**Subject: Watts Bar Nuclear Plant (WBN) Unit 2 - Intake Pumping Station  
Water Velocity – Response to Request for Additional Information**

### Response to Intake Pumping Station Water Velocity RAI

#### Tennessee Valley Authority – Watts Bar Nuclear Plant - Unit 2, Docket No. 50-391

## IPS Plan View Schematic

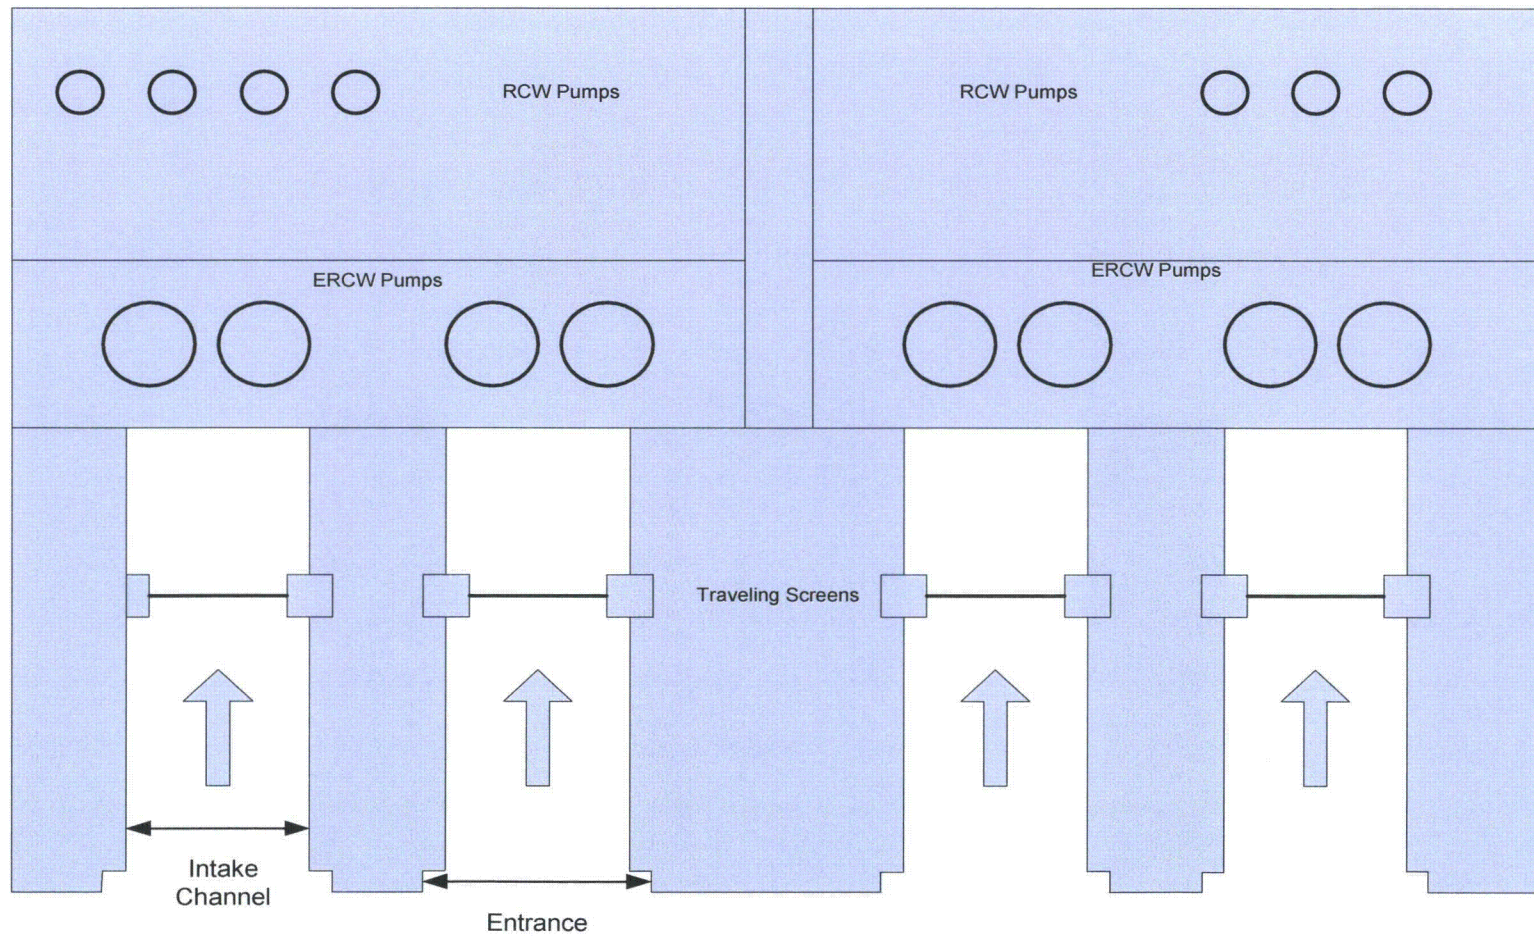
*At a meeting with the NRC on May 11, 2011, the NRC staff reviewing the impingement report had a number of basic questions concerning the physical configuration of the Watts Bar Nuclear Plant Intake Pumping Station (IPS) and pump alignment and operation.*

Eight Essential Raw Cooling Water (ERCW) pumps and seven Raw Cooling Water (RCW) pumps are located at and take suction from the IPS. ERCW serves safety-related loads such as Residual Heat Removal and Component Cooling System heat exchangers. RCW supplies non-safety loads such as cooling units of normal building ventilation systems and turbine oil cooling. Many of the loads for both ERCW and RCW are systems that are shared between both units. These loads have to be supplied whether a single unit or both units are in operation. Spent Fuel Pool heat removal and building ventilation heat loads are examples of shared loads.

The ERCW system is safety-related and is required to have two independent trains to meet single failure requirements. The IPS as a consequence has two physically separated independent bays. The four train A ERCW pumps are located in one bay and the four train B ERCW pumps are located in the other bay. The RCW pumps are not safety-related, but they are divided between the two bays to even the flow load. There are four RCW pumps located in one bay and three located in the other bay. The RCW pumps are physically separated from the ERCW pumps but share common suction paths from the river through the traveling screens. The IPS has four entrance openings at the river, four intake channels that are always submerged, four traveling screen wells, and four traveling screens. These features are evenly divided between the two bays. This arrangement is shown in Figure 1. Figure 2 shows an elevation schematic. The figures are provided to aid in understanding the arrangement. They are not intended to reflect the detailed physical configuration of the IPS.

Each entrance opening is 7.33 feet (ft) wide. Each intake channel has a rectangular cross section with a width of 5.17 ft and a height of 17.5 ft. The bottom elevation of the channel is 652 mean sea level (msl) and the top of the channel is at 669.5 msl. Each channel empties into a well that includes a traveling screen. The bottom elevation of the well is 652 msl and the top of the well is above the normal maximum lake level. Each well is 5.17 ft wide. Each traveling screen is four ft wide. The height of the water column through the well and through the traveling screen varies with the lake level. The minimum summer pool elevation is 681 msl and the minimum winter pool elevation is 677 msl. The minimum seasonal pool elevations were used for calculating the velocities through the traveling screen. The specific height values used were 29 ft for the summer and 25 ft for the winter. Since there are two flow paths into each bay, the flow area per bay is twice the width times the height for each path. The area through the traveling screen is also multiplied by a factor from the manufacturer to account for the effective flow area. This value is 0.503 for the WBN screens. The velocity in the wells was not calculated but would be the velocity of the intake channel multiplied by the ratio of 17.5 ft/29 ft for the summer and 17.5/25 for the winter.
